ADDENDUM ONE
NORTH ST ELMO DRAINAGE SYSTEM STUDY AND UPGRADE
CONTRACT NUMBER S-09-008-201
CITY OF CHATTANOOGA, TENNESSEE

The following changes shall be made to the Contract Documents, Specifications, and Drawings:

SHEET 02A OF 28

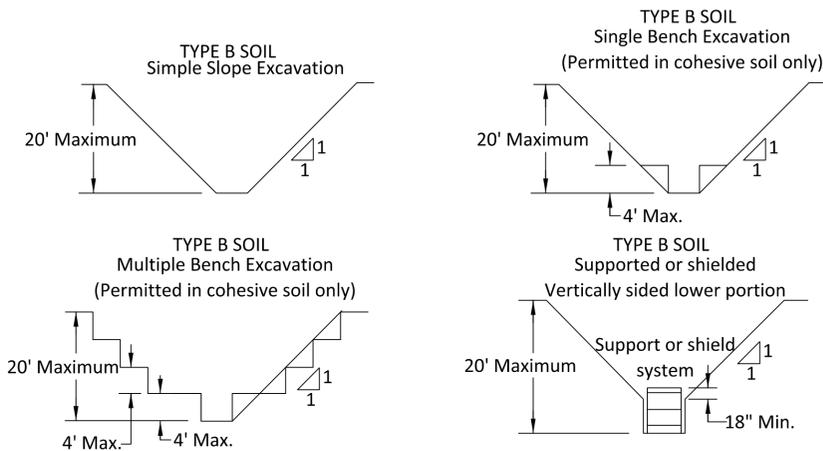
DATE	REVISION DESCRIPTION
4-18-16	ITEM APPENDIX B-1 MOVED TO THIS PAGE

TRENCH NOTES AND PROPERTY REQUIREMENTS TABLE

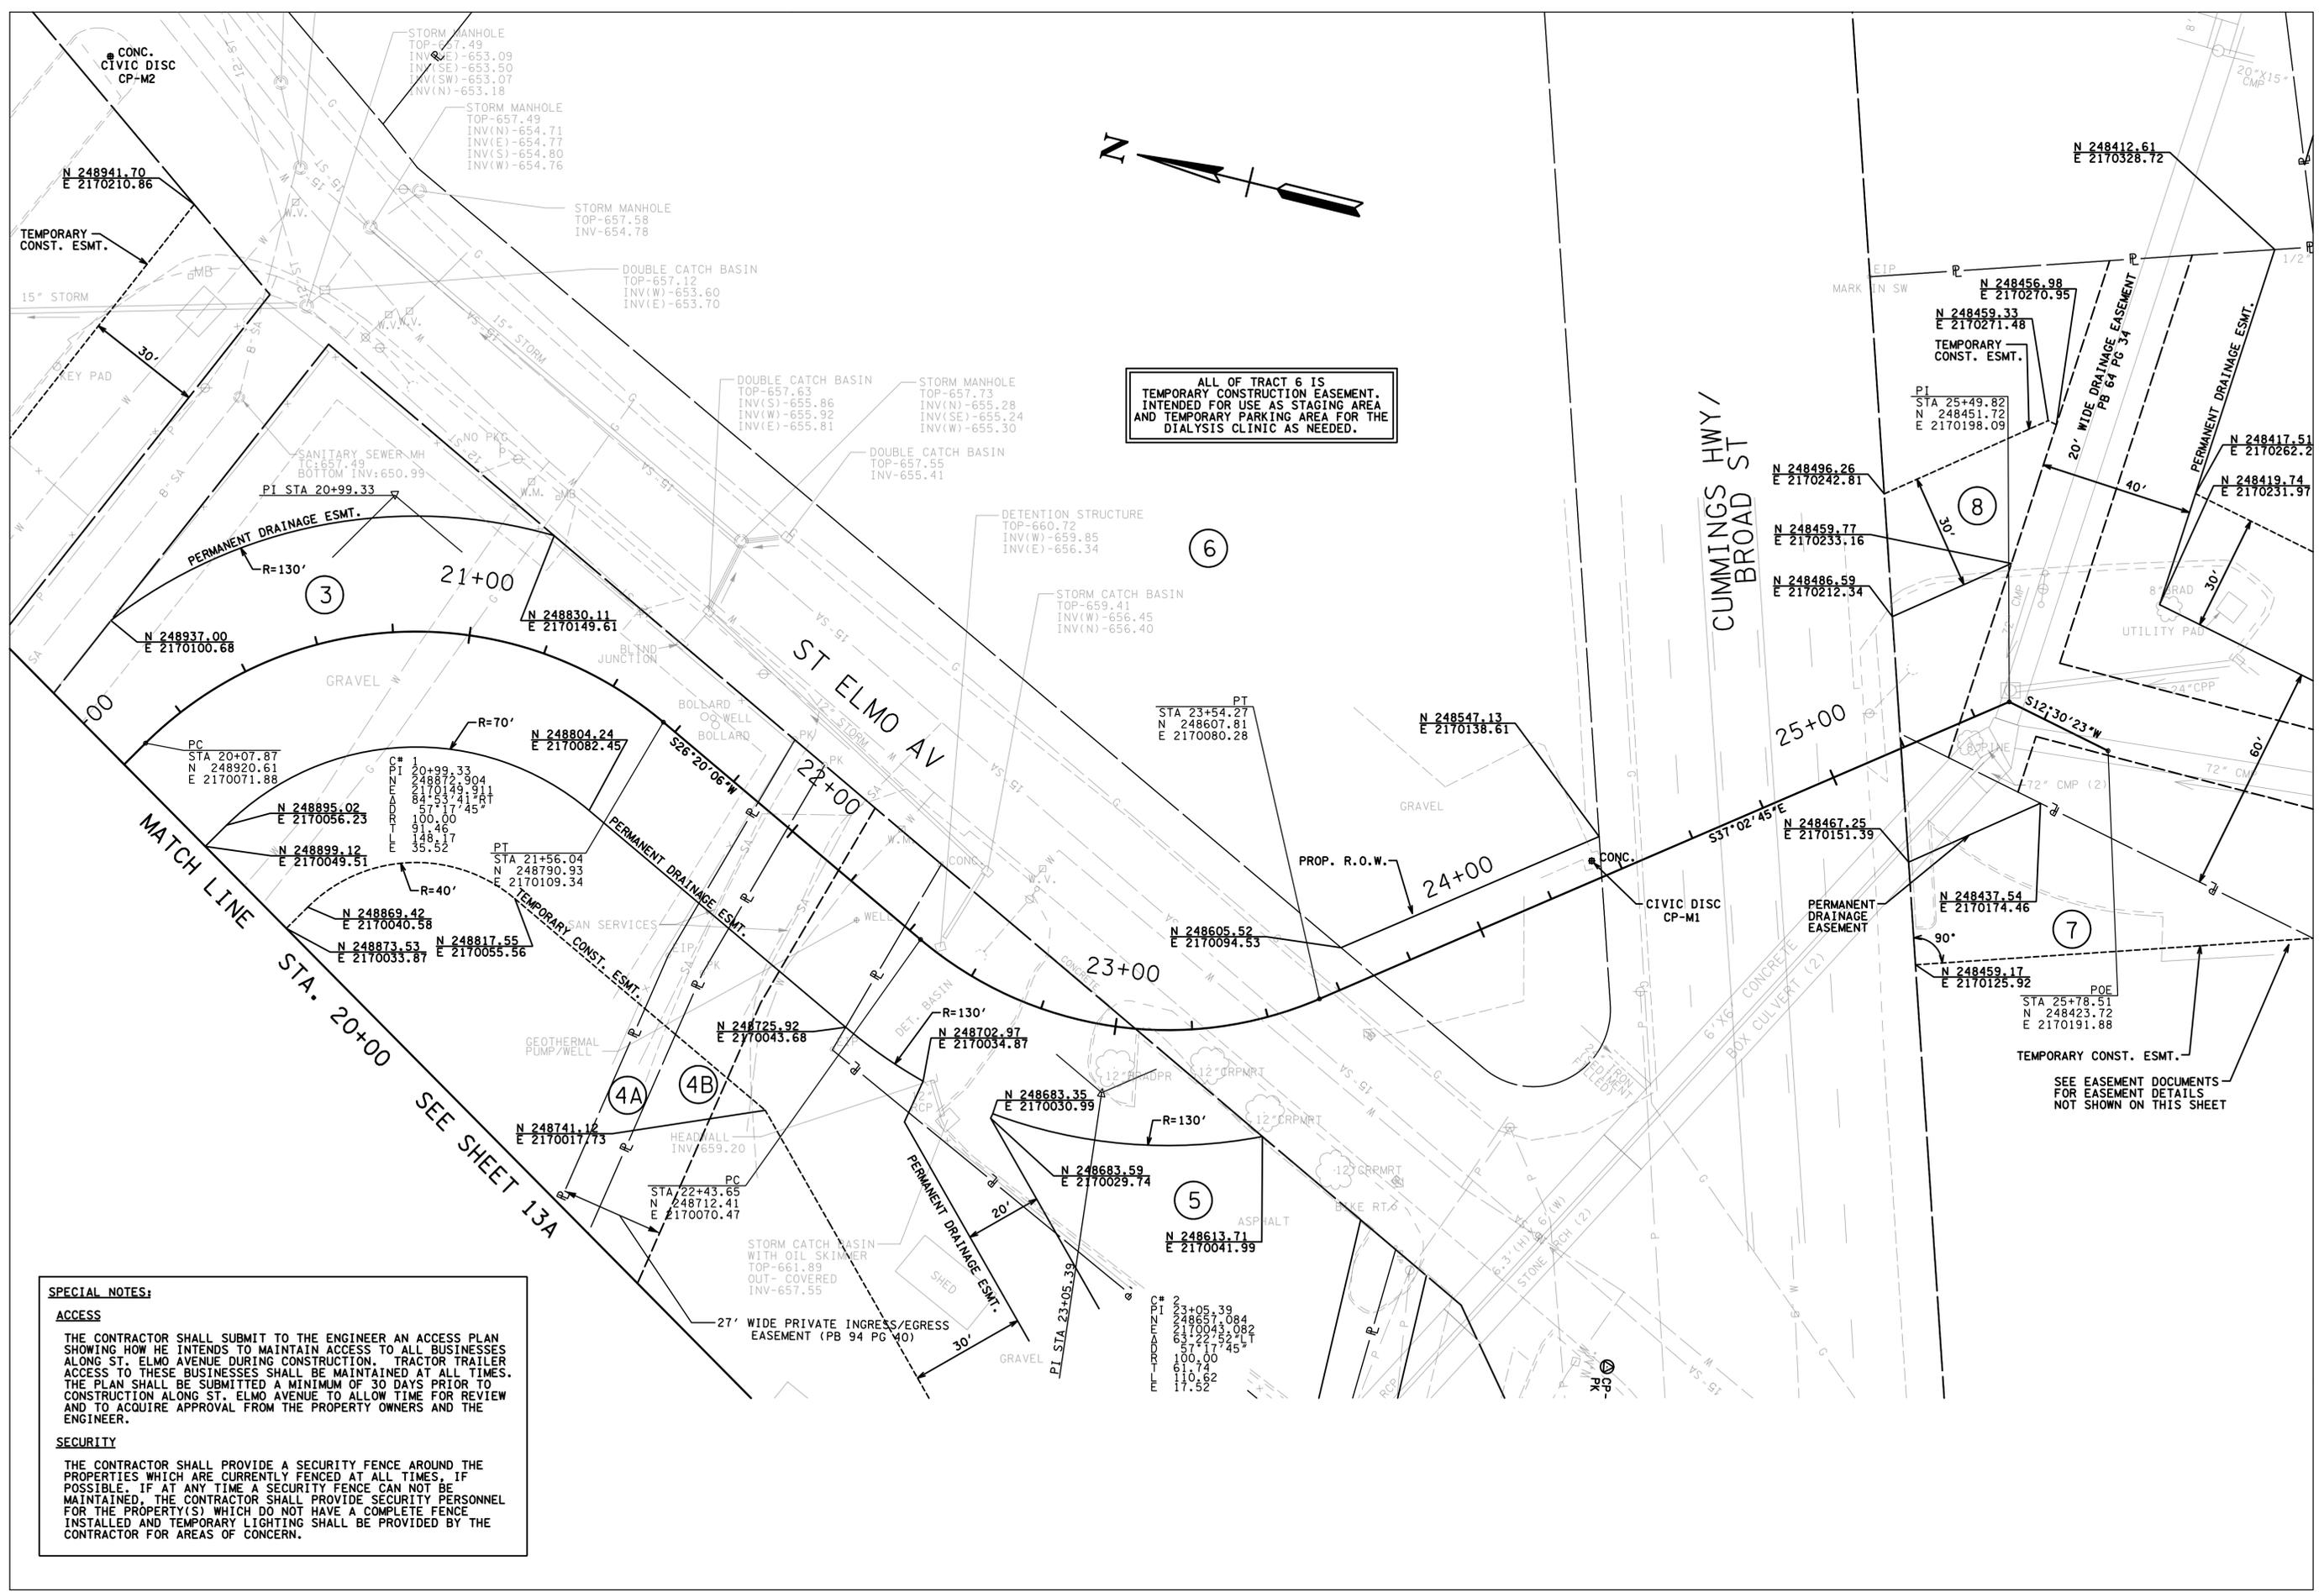
REVISION DESCRIPTION	DATE
REQUIREMENTS 1-2 ADDED TO TRACT 4A	4-18-16

4A	RANDY TUTTON	3523 ST ELMO AV	1. A SECURITY FENCE SHALL BE MAINTAINED AROUND THE PROPERTY AT ALL TIMES. IF A SECURITY FENCE CAN NOT BE FEASIBLY MAINTAINED, THE CONTRACTOR SHALL PROVIDE LIGHTING FOR AREAS OF CONCERN AND SECURITY PERSONNEL FOR THE PROPERTY DURING NON-BUSINESS HOURS. 2. FULL ACCESS SHALL BE MAINTAINED TO THE PROPERTY AT ALL TIMES.
4B	BEAR BRANCH INC	3535 ST ELMO AV	NO SPECIAL REQUIREMENTS
5 / 9	DIALYSIS CLINIC INC	3655 ST ELMO AV	1. THE GRAVEL PARKING LOT ON TRACT 4B SHALL BE USED FOR THE DIALYSIS CLINIC TEMPORARY PARKING AREA. A GATE WITH GRAVEL WALKWAY SHALL BE INSTALLED IN THE CHAIN LINK FENCE BETWEEN TRACTS 4B AND 9 OR TRACTS 4B AND 5 TO PROVIDE ACCESS TO THE DIALYSIS CLINIC FROM THE GRAVEL PARKING AREA ON TRACT 4B. THE GATE LOCATION SHALL BE APPROVED BY THE PROJECT MANAGER. 2. THE ASPHALT PARKING / ACCESS AREA BEHIND THE CLINIC SHALL REMAIN OPEN TO MOTORISTS THROUGHOUT CONSTRUCTION. 3. UNDER NO CIRCUMSTANCES SHALL WATER SERVICE BE DISRUPTED TO THE DIALYSIS CLINIC. IF A CIRCUMSTANCE ARISES DURING CONSTRUCTION WHICH COULD POTENTIALLY DISRUPT WATER SERVICE DUE TO UNANTICIPATED WATER MAIN OR SERVICE LINE DAMAGE, THE CONTRACTOR SHALL COORDINATE WITH THE WATER UTILITY AND PROPERTY OWNER PRIOR TO CONSTRUCTION IN THIS AREA TO DETERMINE A SUITABLE PLAN OF ACTION IN THE EVENT THE WATER SERVICE IS DISRUPTED.

EXISTING
 STORM SYSTEM
 ABANDONMENT
 PLAN

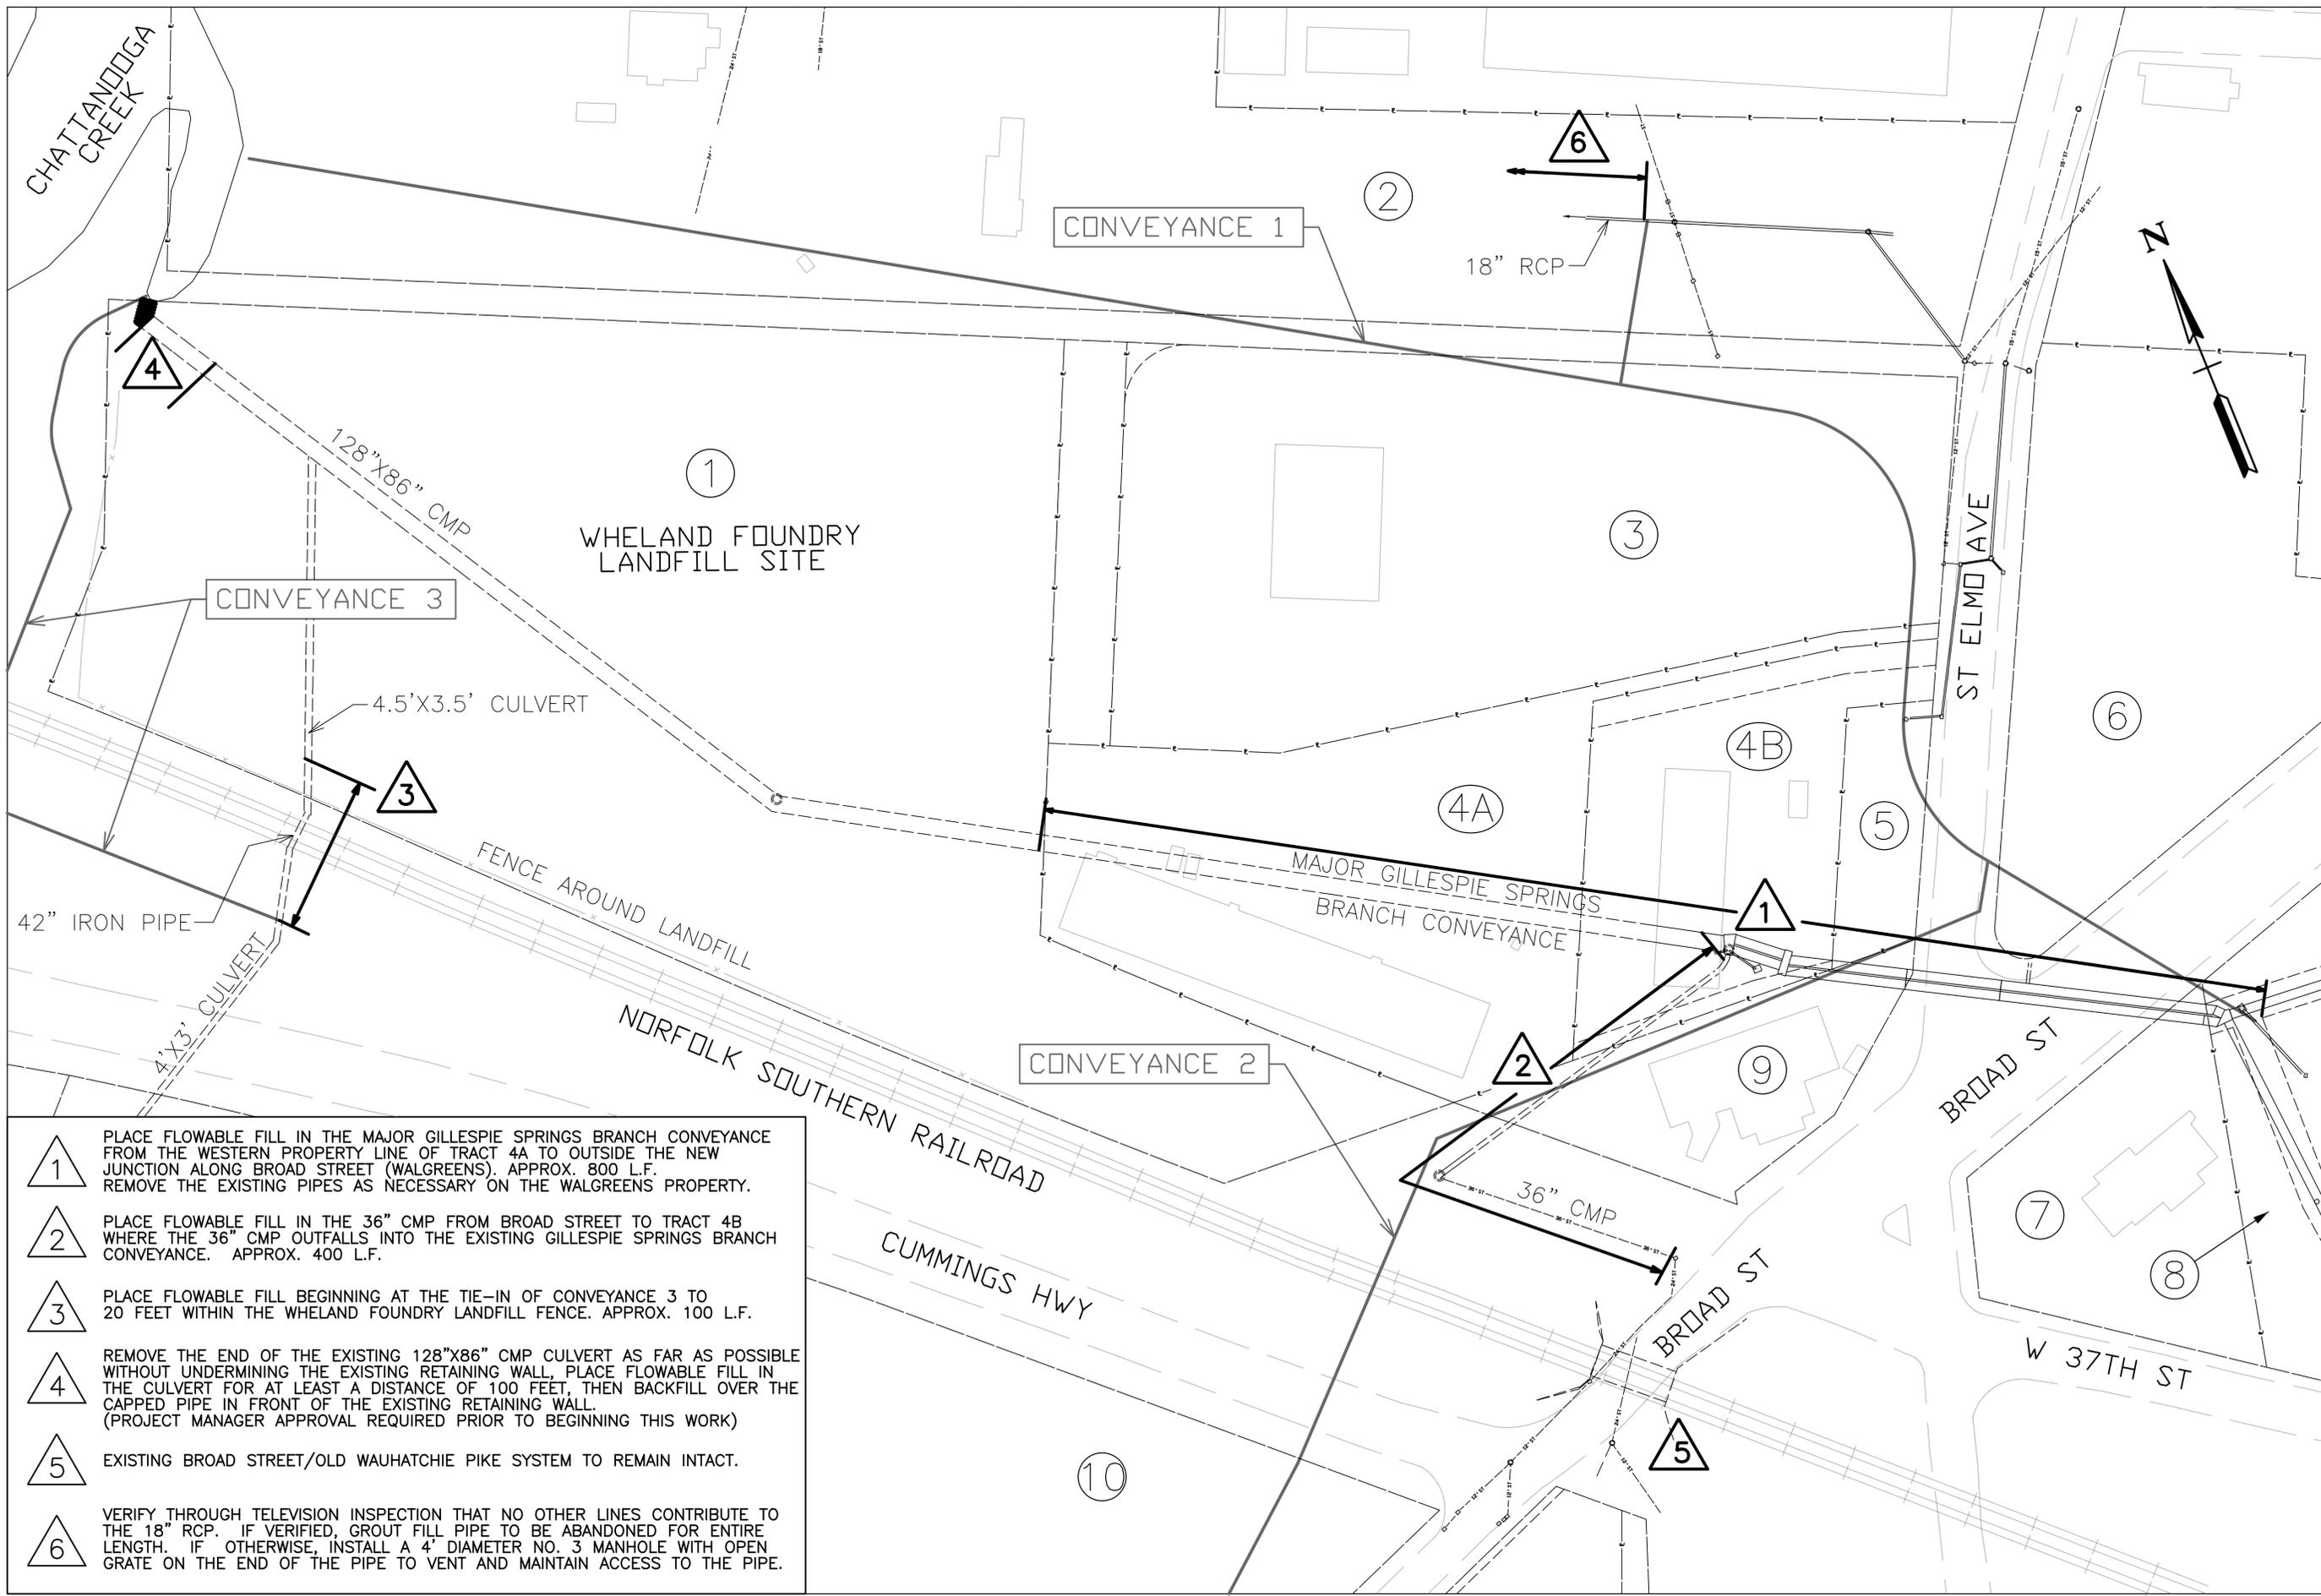
DATE	REVISION DESCRIPTION
4-18-16	REVISED NOTES ON ITEM 4 WORK

- ③ PLACE FLOWABLE FILL BEGINNING AT THE TIE-IN OF CONVEYANCE 3 TO 20 FEET WITHIN THE WHELAND FOUNDRY LANDFILL FENCE. APPROX. 100 L.F.
- ④ REMOVE THE END OF THE EXISTING 128"x86" CMP CULVERT AS FAR AS POSSIBLE WITHOUT UNDERMINING THE EXISTING RETAINING WALL. PLACE FLOWABLE FILL IN THE CULVERT FOR AT LEAST A DISTANCE OF 100 FEET, THEN BACKFILL OVER THE CAPPED PIPE IN FRONT OF THE EXISTING RETAINING WALL. (PROJECT MANAGER APPROVAL REQUIRED PRIOR TO BEGINNING THIS WORK)
